**BLUE COLUMBINE
COHOUSING**

50% SD

**FLOOR PLAN
UNIT TYPE F (1,232 SF)**

06.03.2025

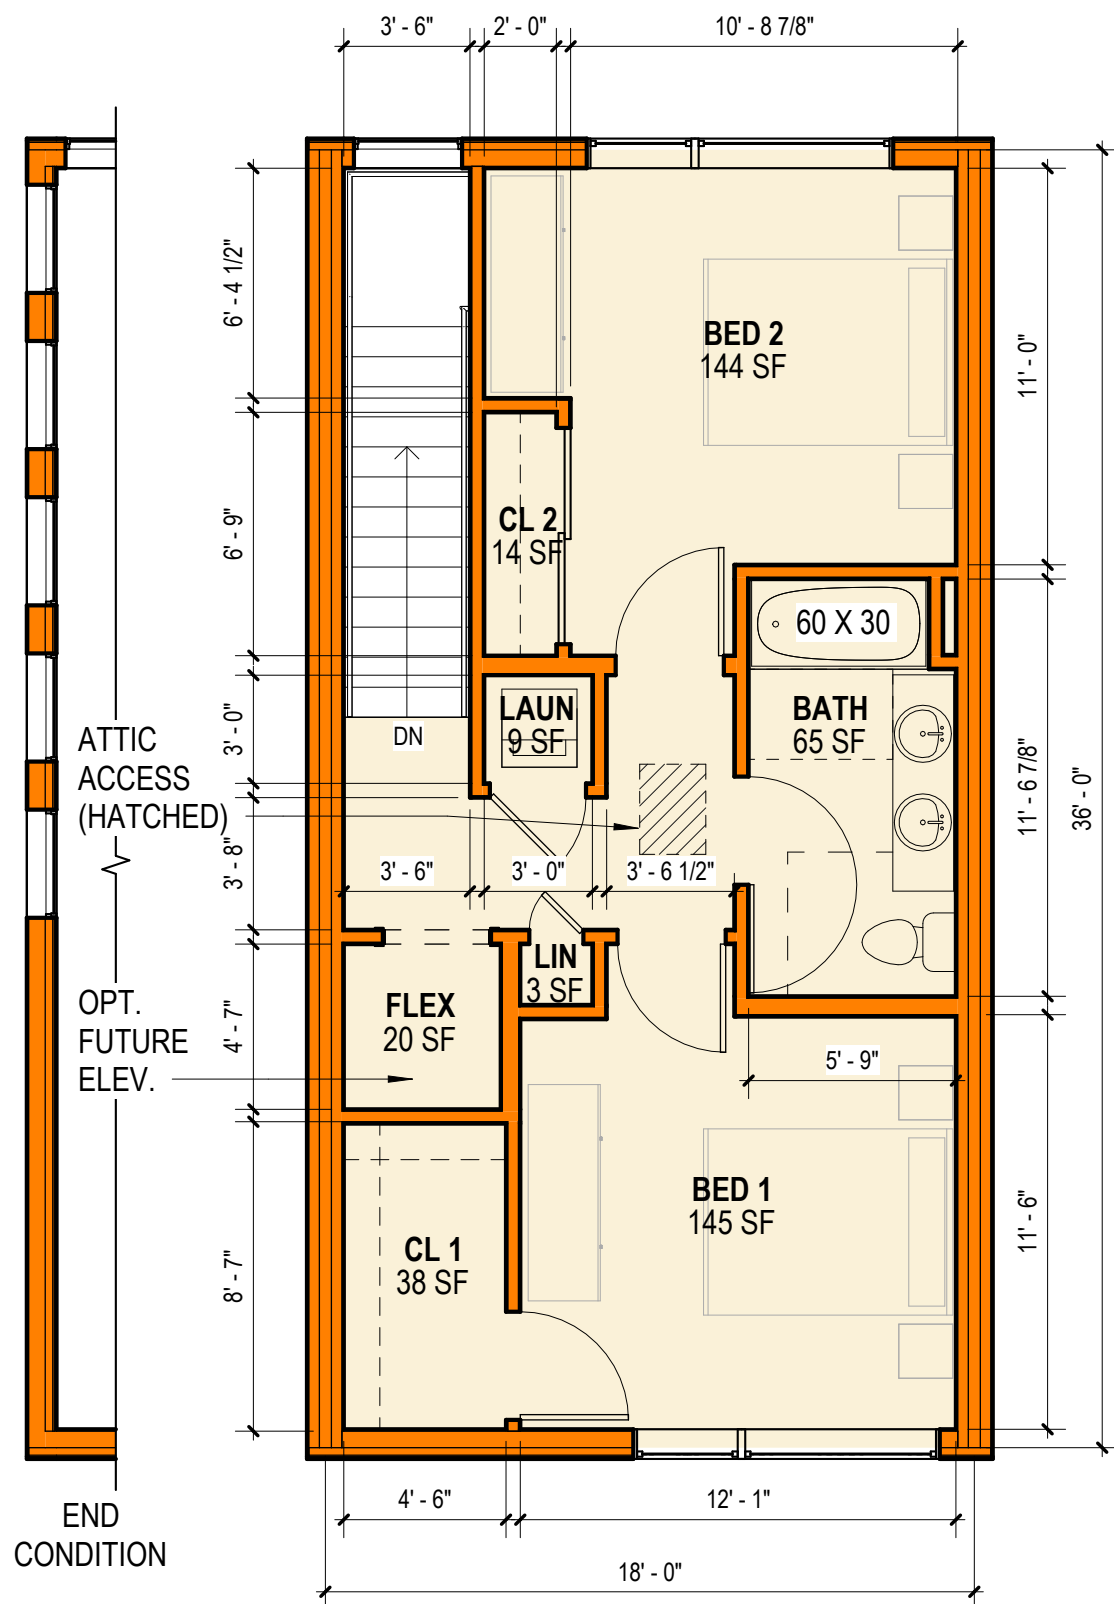
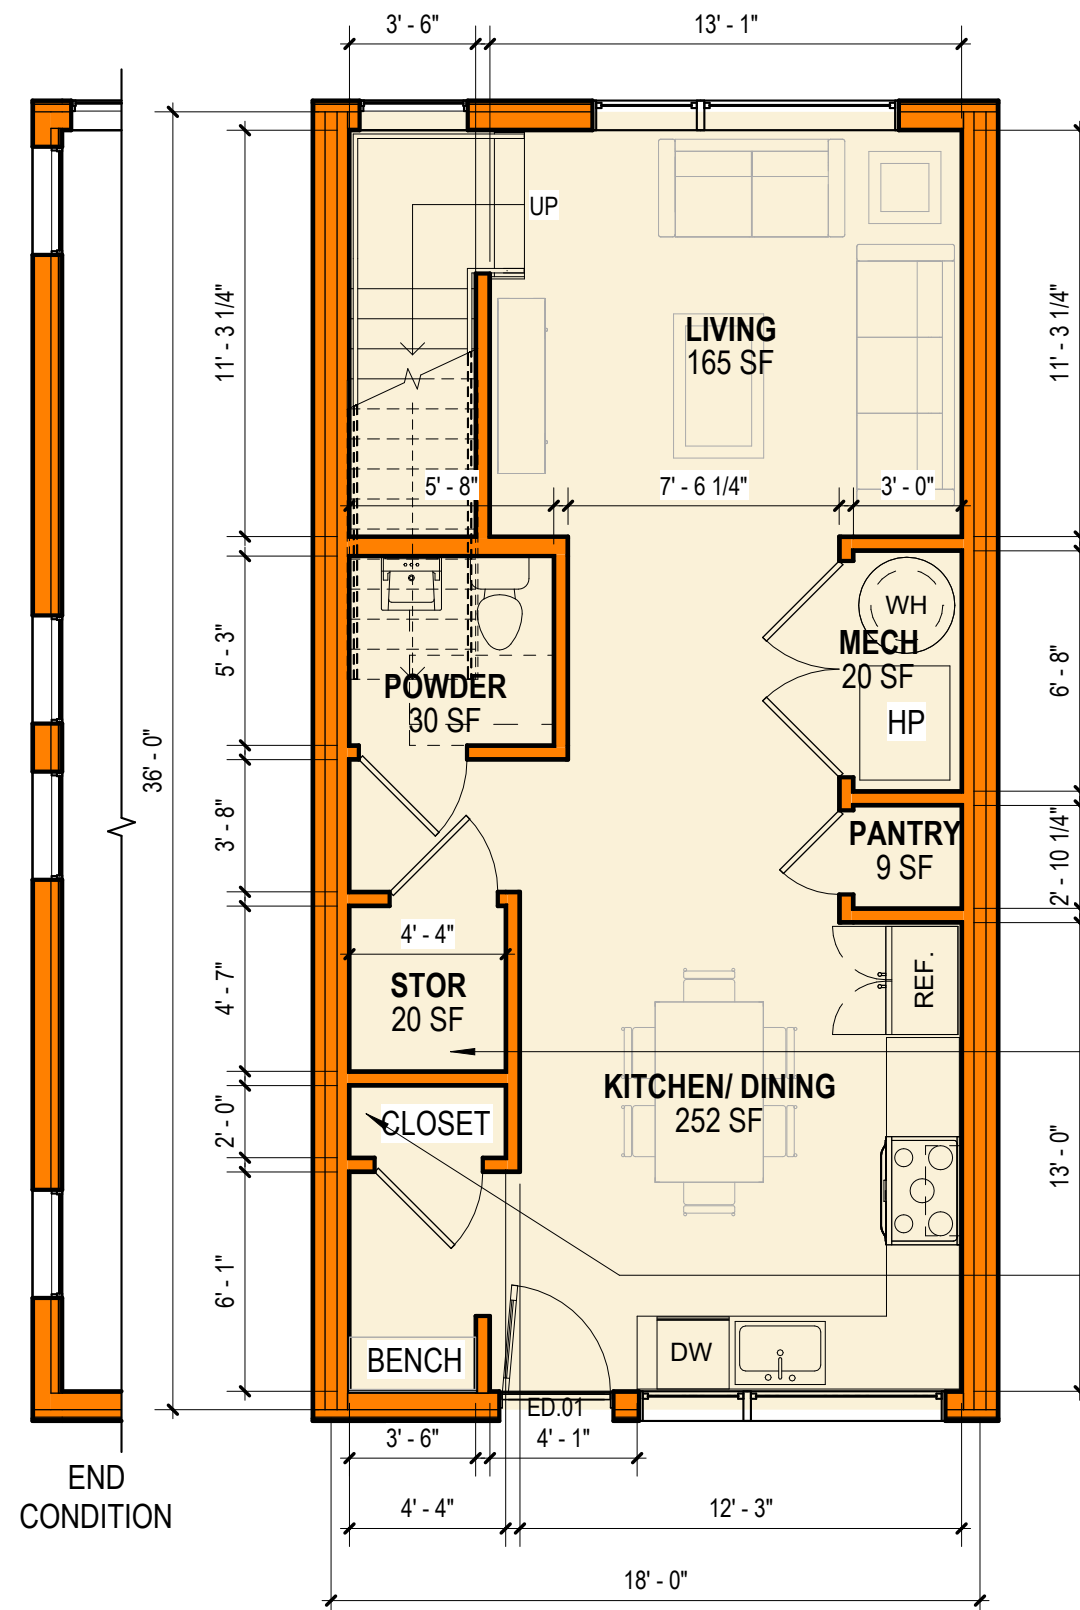
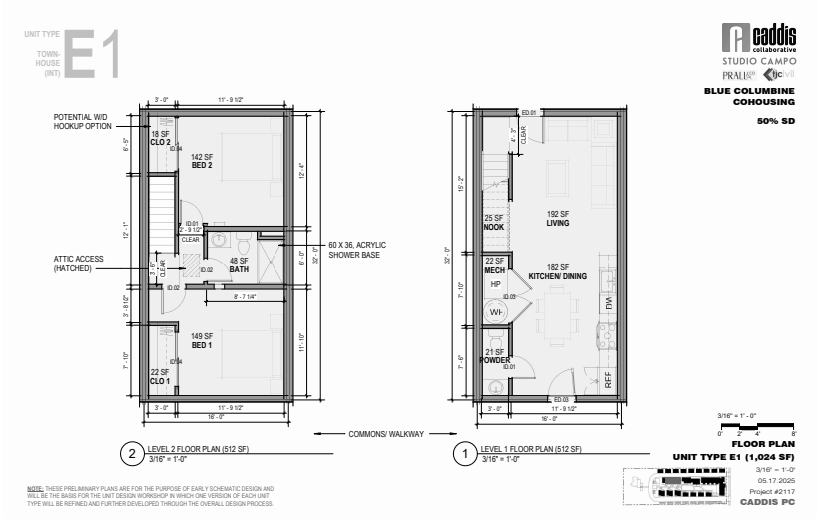
- PLAN DESIGNATION CHANGED FROM 'E' TO 'F'
- OVERALL PLAN DIMENSIONS INCREASED FROM 16'X32' TO 18'X36'; AN INCREASE OF **208 SF**
- KITCHEN LAYOUT CHANGED FROM LINEAR TO 'L' AND ENTRY MOVED ACCORDINGLY
- DROP ZONE ADDED ADJACENT TO ENTRY
- REAR DOOR OMITTED
- TYPE 'B' ACCESSIBILITY CLEARANCES PROVIDED THROUGHOUT LEVEL 1. LEVEL 2 LAYOUT MADE 'ADAPTABLE' TO ACCOMMODATE FUTURE ACCESSIBILITY WITH POTENTIAL FUTURE ELEVATOR
- ELEVATOR AND MACHINE ROOM SPACES PROVIDED
- END UNIT CONDITION FLIPPED SO ORIENTATION OF UNITS REMAINS CONSISTENT AND TO ALLOW FOR MORE FENESTRATION
